AMERICAN SUZUKI MOTOR CORPORATION

The following information is submitted in accordance with the reporting regulations in Title 49 of the Code of Federal Regulations, Part 579, Subpart B - Reporting of Safety Recalls and Other Safety Campaigns in Foreign Countries.

4. Description of Defect

PCB of Cam Sensor

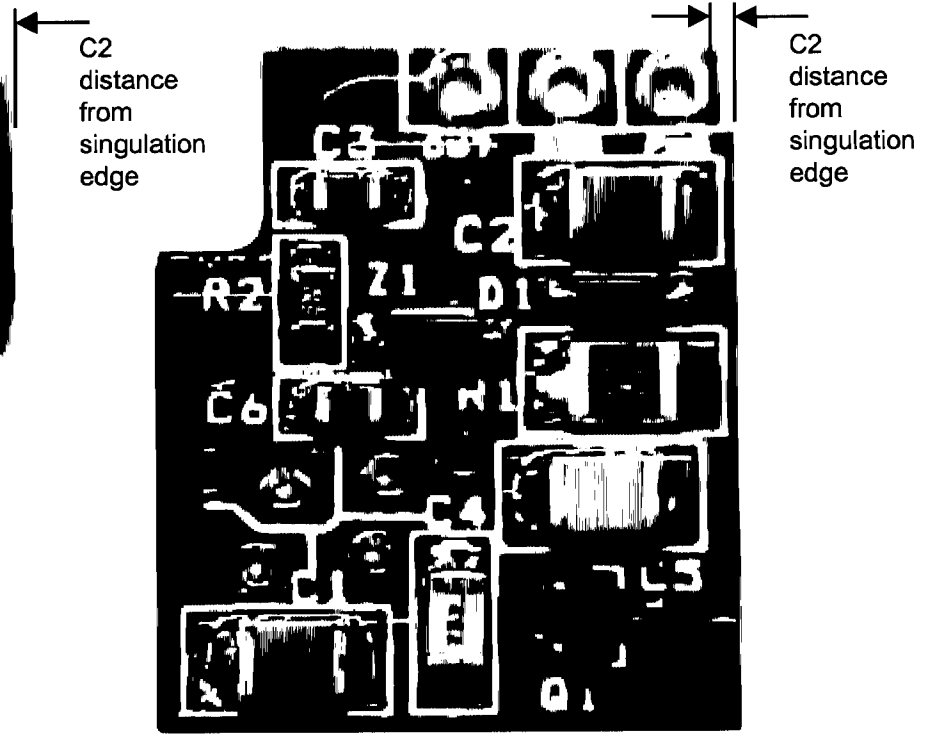
The reason of voluntary recall is a possible crack in C2 capacitor on the suspect PCB (Printed Circuit Board) of cam sensor. The crack might be resulted from the stress of PCB cutting process in PCB maker's manufacturing process (AB automotive)

But the original PCB had different circuit design (the distance between C2 capacitor and cutting line) and provided from another maker (Windsor)
